Uptown Urban Center Rezone

FINAL ENVIRONMENTAL IMPACT STATEMENT

CITY OF SEATTLE UPTOWN URBAN CENTER REZONE (UPTOWN REZONE)

March 23, 2017

Exhibit 2-3 Future Land Use Map, 2015

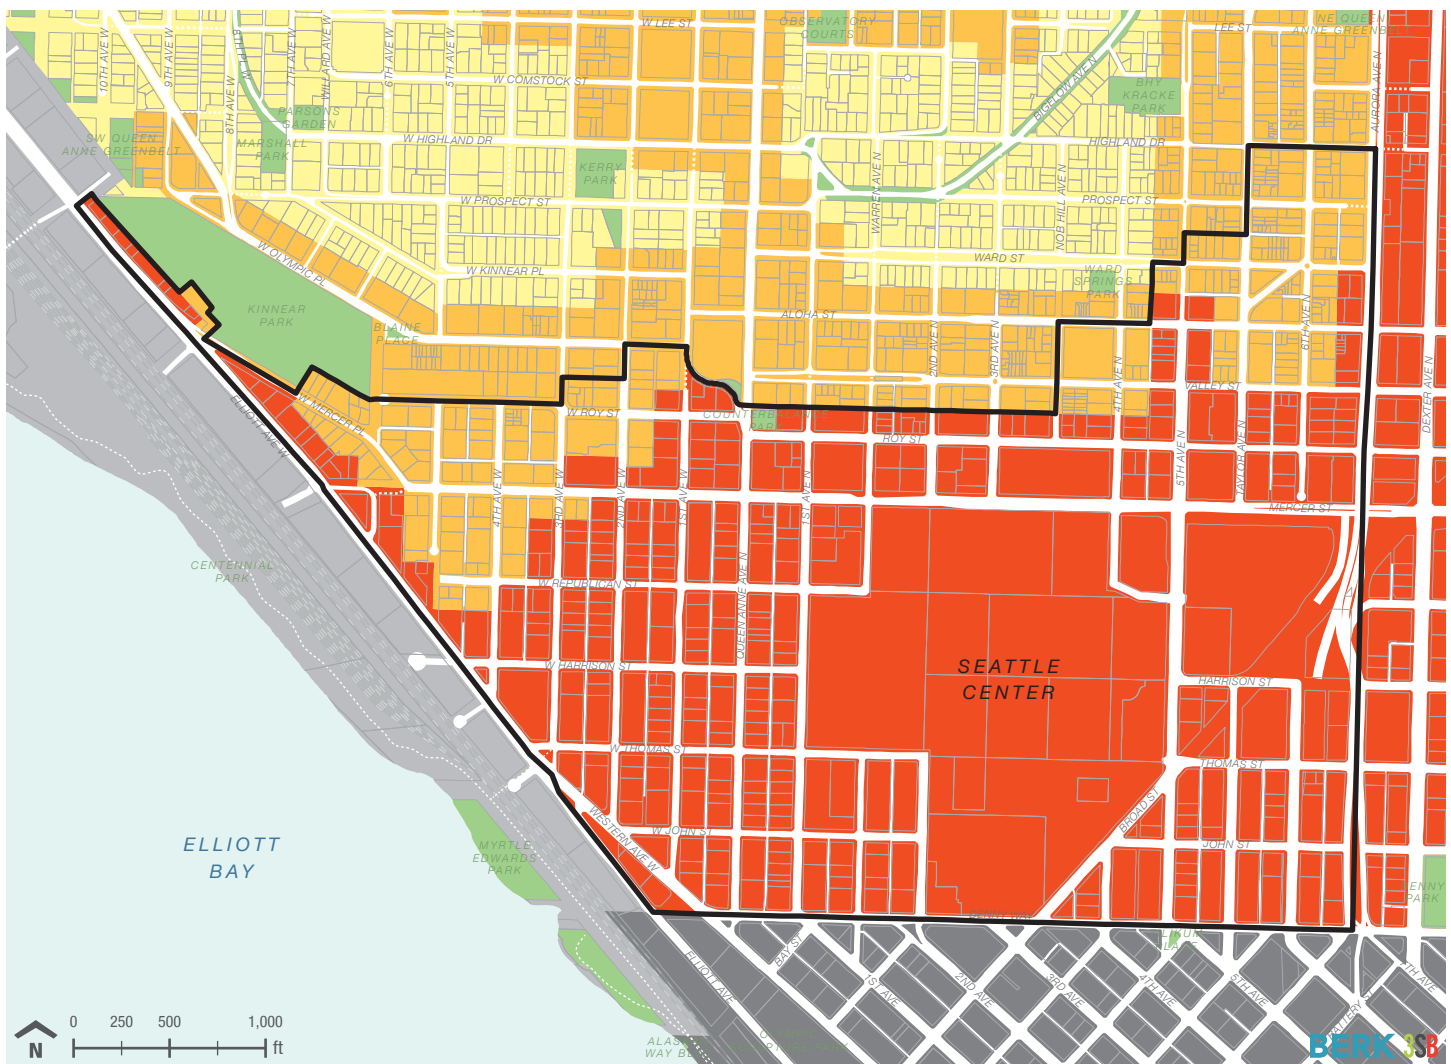
Exhibit 2-3 on page 2.7 of the Draft EIS shows future land uses as designated on the City of Seattle Comprehensive Plan Future Land Use Map. A correction has been made to the legend of Exhibit 2-3 in Chapter 4 of this Final EIS to clarify that the exhibit shows future land uses, not current land uses. Current City zoning for the Seattle Center is consistent with the Comprehensive Plan Future Land Use Map.

Page 2.7, Exhibit 2-3 Future Land Use Map, 2015, correct legend title:

Exhibit 2-6 Neighborhood Character Map

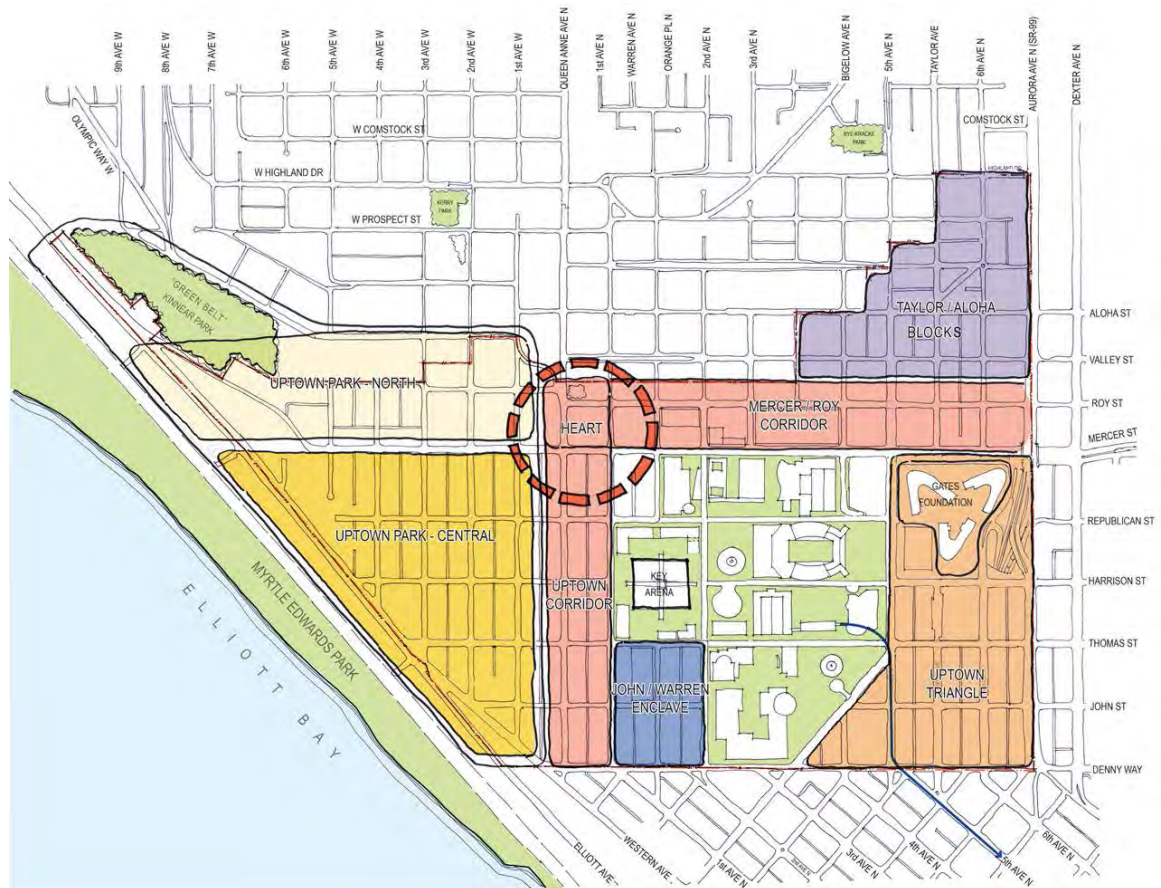
Exhibit 2-6 on page 2.10 of the Draft EIS is an image taken directly from the Uptown UDF. The purpose of this image is to show the desired neighborhood character described in the Uptown UDF. It is noted that this image does not label Centennial Park, the Helix Bridge or Thomas Street connection.

Exhibit 2-9 Potential Redevelopable Sites

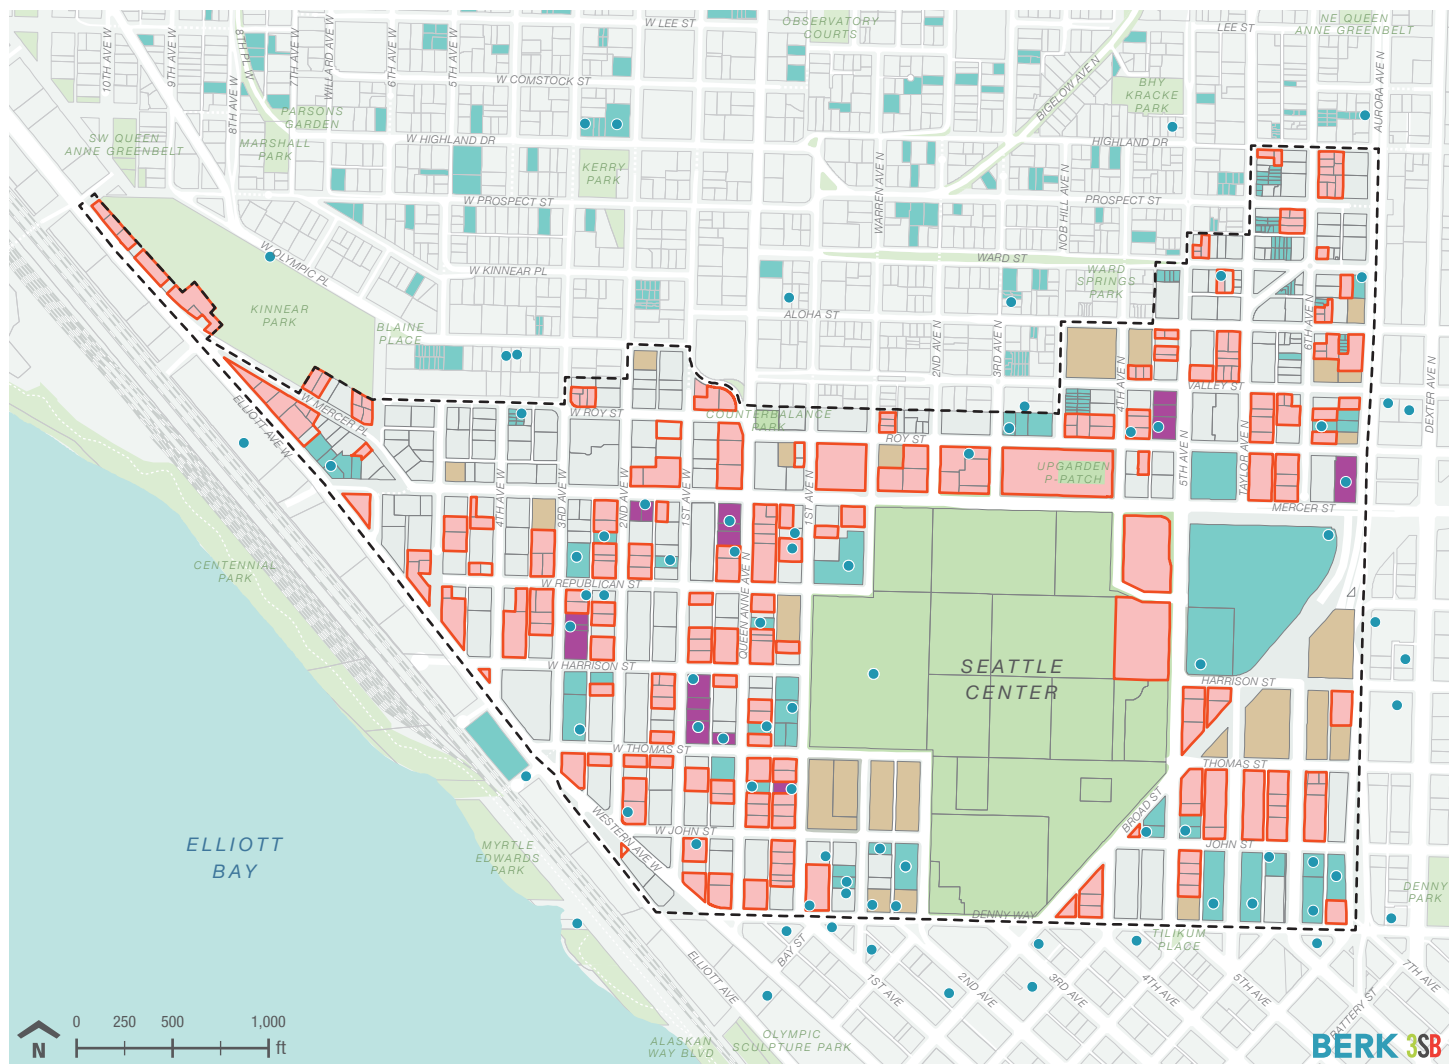
The commenter incorrectly states that the proposal designates "Development Zones" on 5th Avenue W and Republican. The comment references Draft EIS Exhibit 2-9, which shows potential redevelopable sites. These sites exhibit one or more of the following characteristics: existing buildings are ≤ 25 percent of what current zoning allows, buildings are relatively lower value compared to property values, and parking lots where new uses could be added and parking placed under ground. Draft EIS Exhibit 2-9 is not an indication of owner interest in redevelopment or actual change. Under the Preferred Alternative, which is described in Chapter 2 of this Final EIS, moderate increases in allowed building heights at 5th Ave West and Republican, similar to Alternative 2 Mid-Rise and less than Alternative 3 High-Rise. Any applications for redevelopment of sites within the Uptown study area, whether or not the proposal considered in the EIS is adopted, would be subject to City requirements in the Seattle Fire Code and the Seattle Right of Way Manual.

**Exhibit 3.6-5** Existing Bicycle Facilities

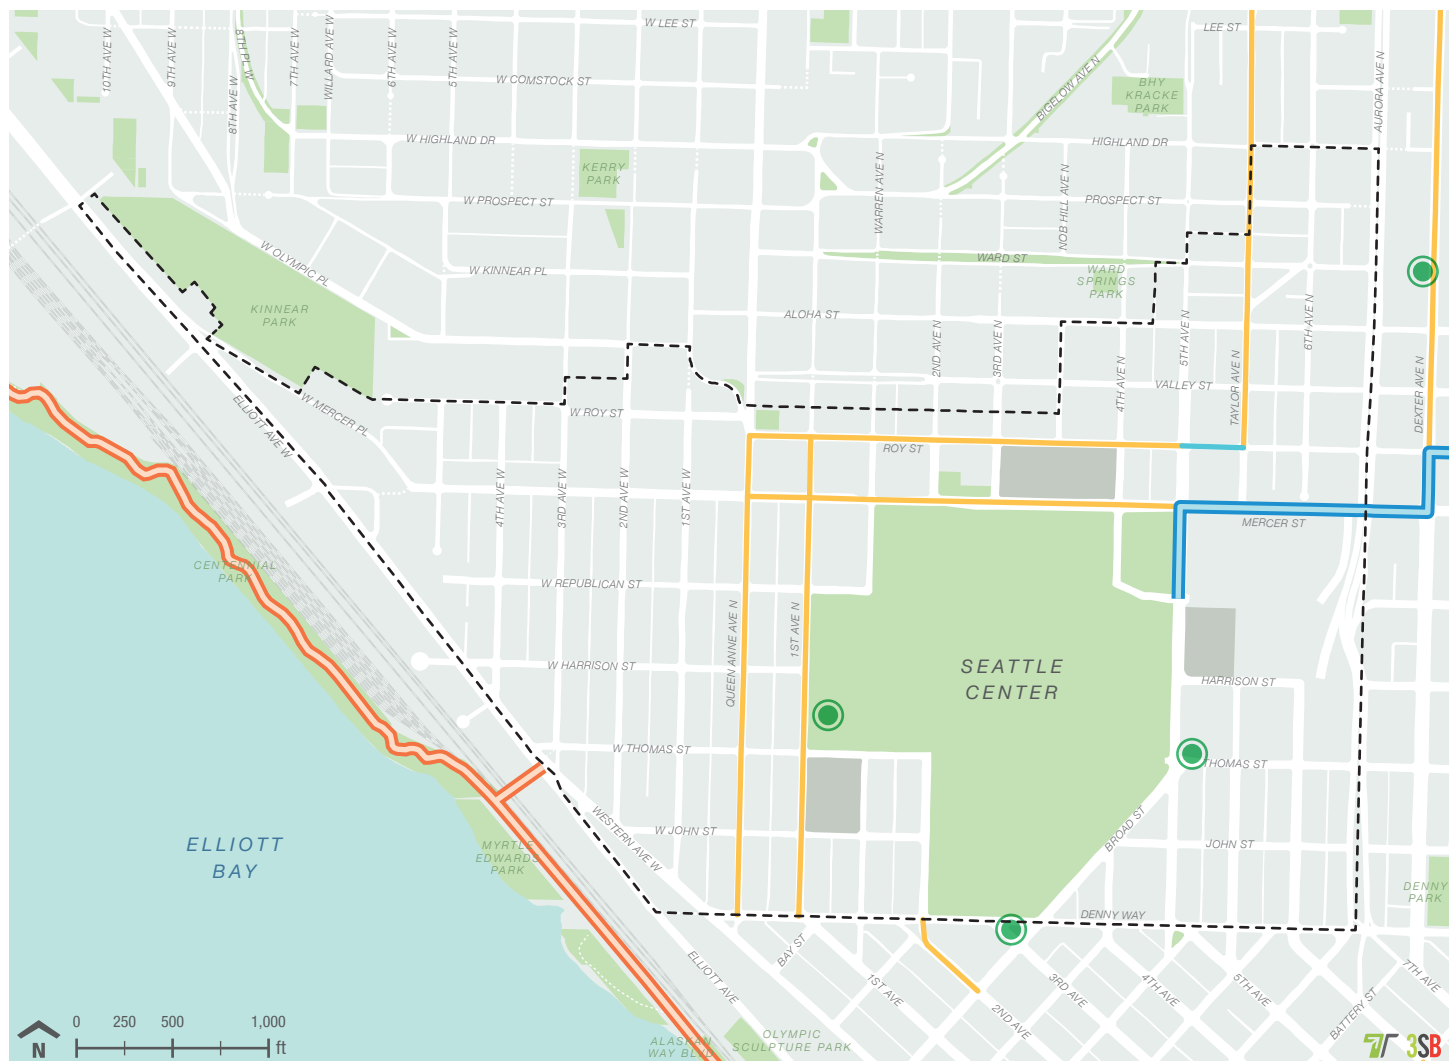
See Chapter 4 of this Final EIS. The Helix Bridge connection is added to Exhibit 3.6-5, and added to the description of multi-use facilities. The duplicate paragraph found on page 3.202 of the Draft EIS is removed.

The Helix Bridge connection is added to Exhibit 3.6-5.
